Re:    **McKendree Springs**  
      **F-09-108**

The following is a point-by-point response to comments from your letter dated November 30, 2009.

RE: File Number: F-09-108  
Title: McKendree Springs Lots 3 & 4 Buildable Pres Par. A

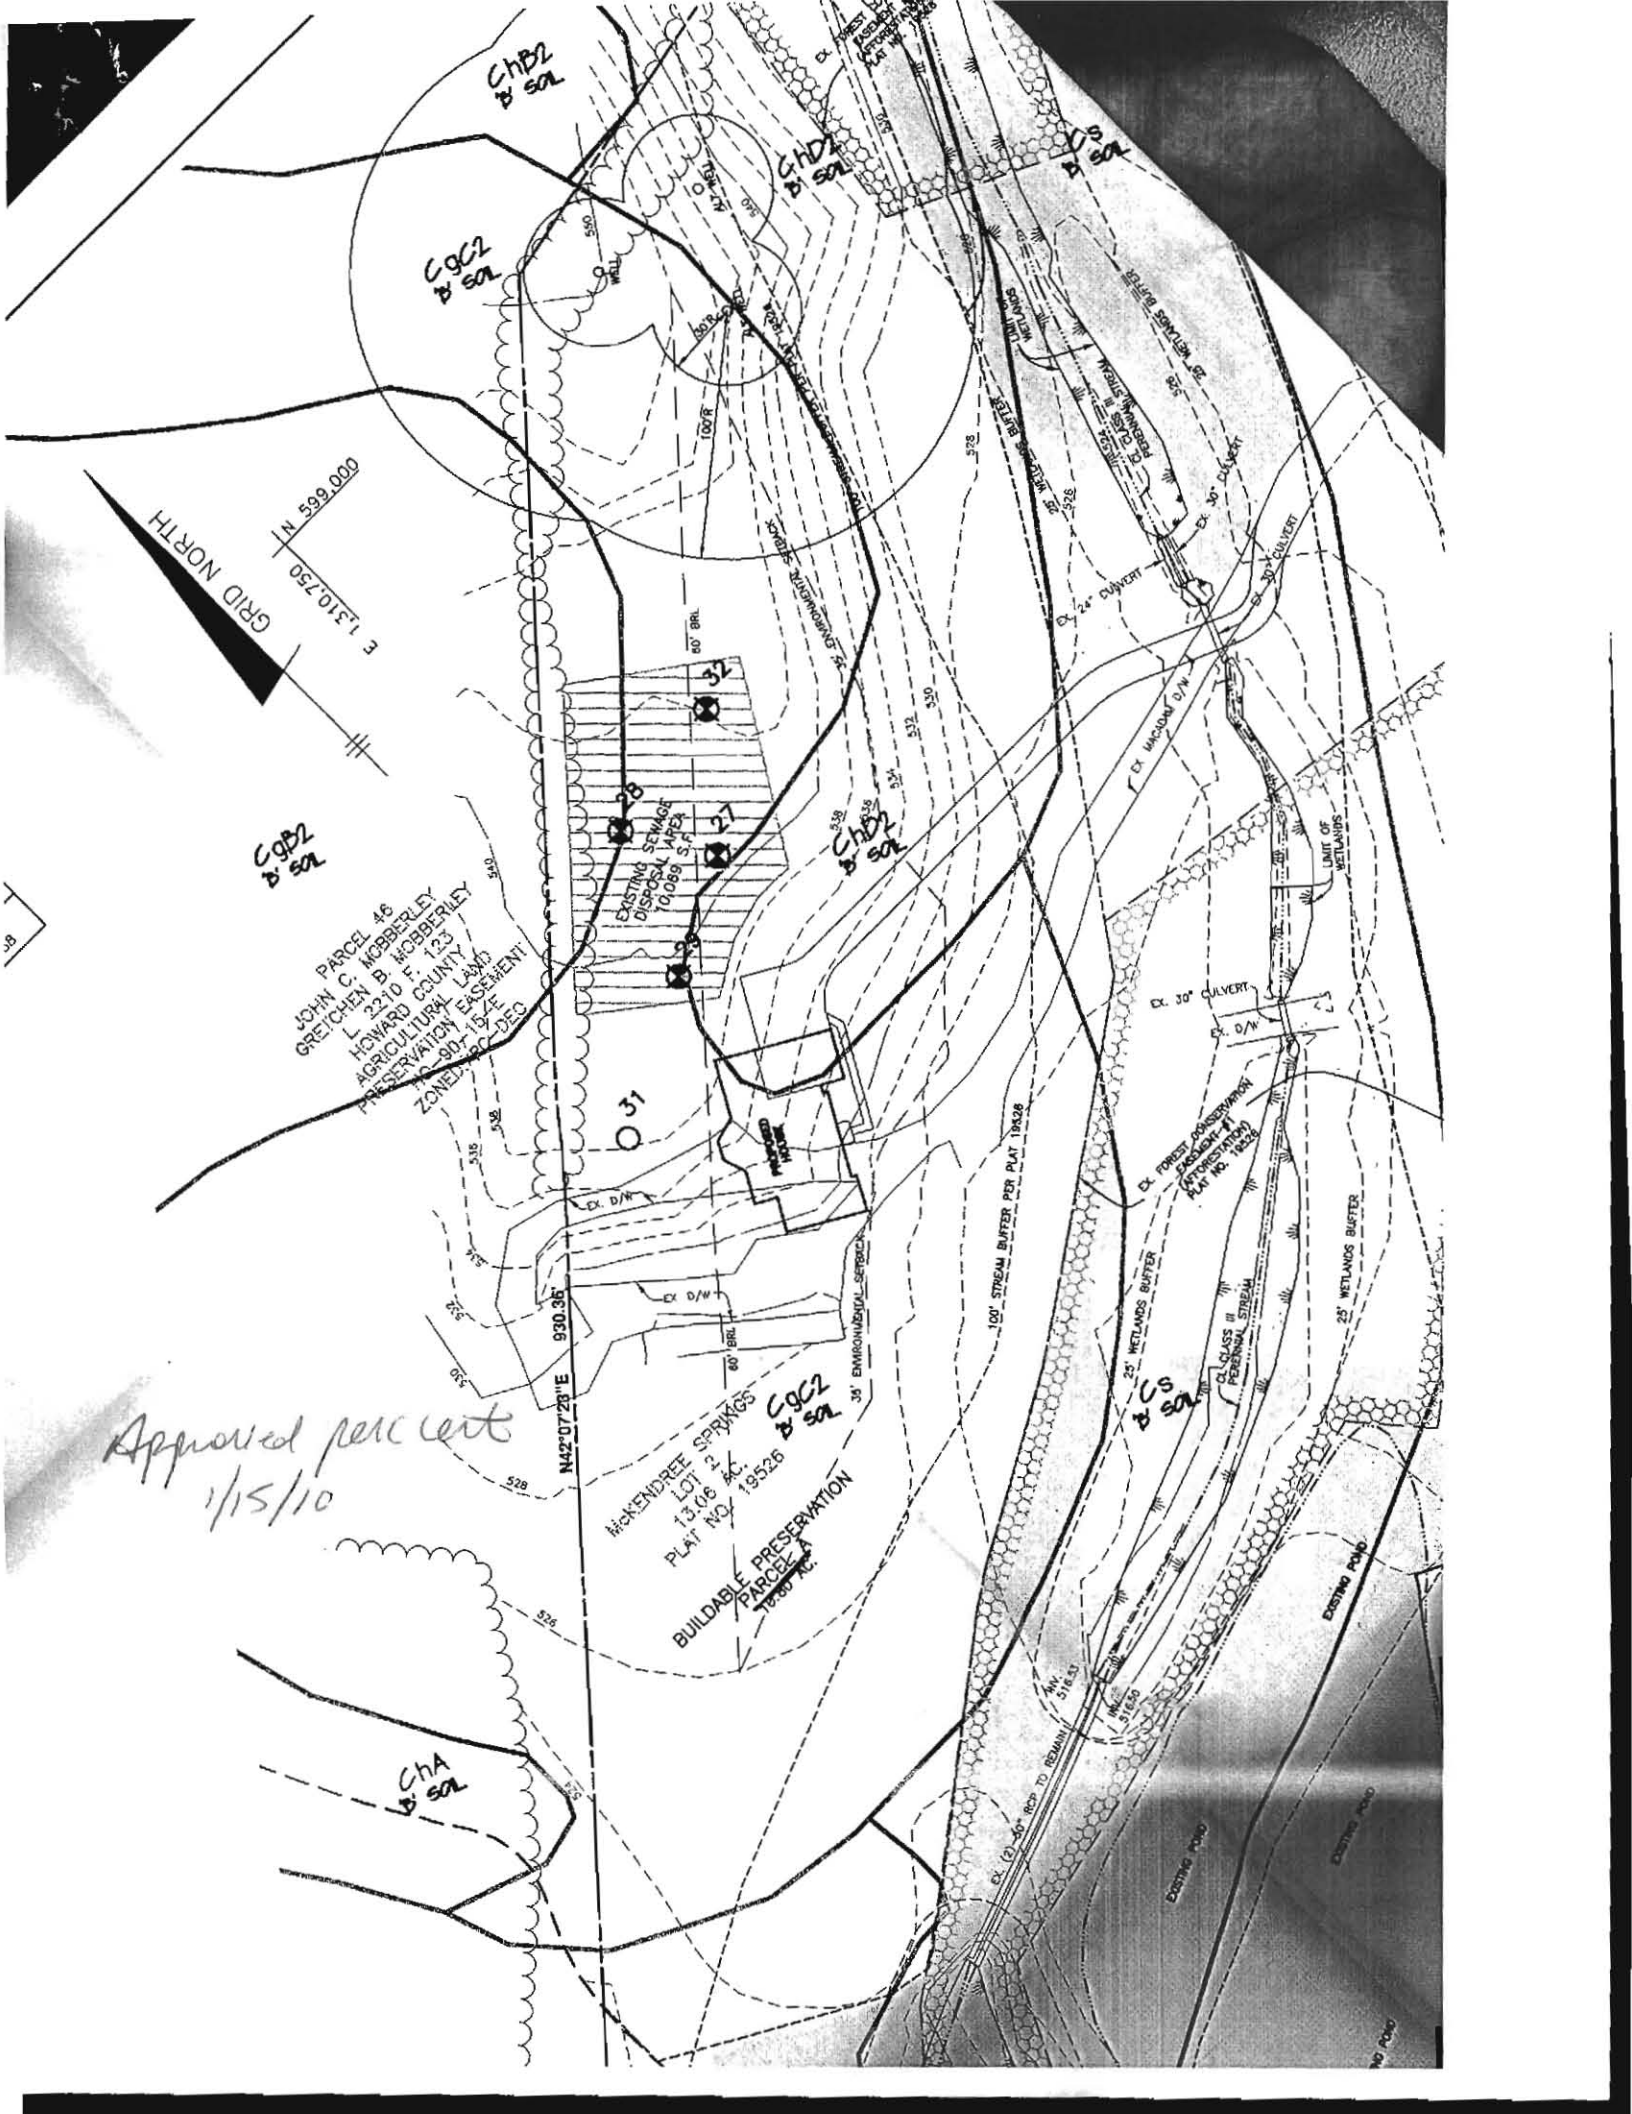
- Percolation certification plan pending
- Include documentation for the abandonment of the existing septic system and existing well on Parcel A
- Wells for Lot 3 and Pres. Parcel A need to be drilled prior to final plat approval
- Adjust roof leader outfalls on Lots 3 and 4 to be 25' from SDA. The closed pipes can be 10' from SDA.

1. It is understood that approval of the percolation certification plan is pending.
2. Per the site visit conducted this morning by the owner and yourself it was determined that there is no existing well on Parcel A. Additional documentation is not required.
3. It is understood that the wells for Lots 3 and Preservation Parcel 'A' need to be drilled prior to final plat approval.
4. The roof leader outfalls, as discussed in our phone conversation this morning, only project 10 feet from the house and meet the 25' setback to the SDA.
